# 9.1 MINUTES OF THE LOCAL TRAFFIC COMMITTEE HELD AT THE BERRIGAN SHIRE COUNCIL OFFICE, CHANTER STREET, BERRIGAN ON 22<sup>ND</sup> JULY, 2014 COMMENCING AT 2:00 PM

RECOMMENDATION – that recommendations numbered 1 to 9 inclusive of the Local Traffic Committee meeting held on  $22^{nd}$  July, 2014 be adopted.

## 6. SCHOOL BUS STOP – BRUCE BIRRELL DRIVE, TOCUMWAL

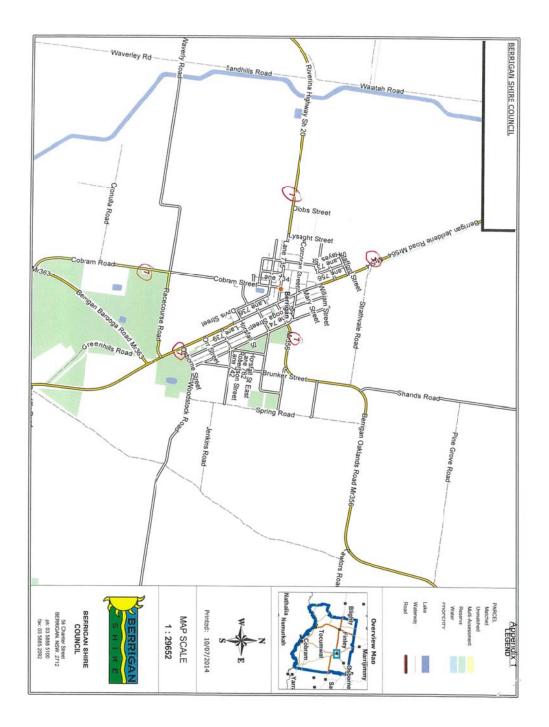
The Committee agreed that the road side at Bruce Birrell Drive and Hunter Drive does not provide adequate width for a safe bus stop and that this could be best addressed by provision of an 'off road' bus stop on the road reserve on the north east side of the intersection as shown below subject to final design and adequate sight distances for turning movements.

**RECOMMENDATION No. 6** - that the school bus stop at the intersection of Bruce Birrell Drive and Hunter Drive be improved by the construction of an 'off road' bus stop on the north east corner of the intersection and that the Committee support an application by Berrigan Shire Council for a grant from RMS for this work.
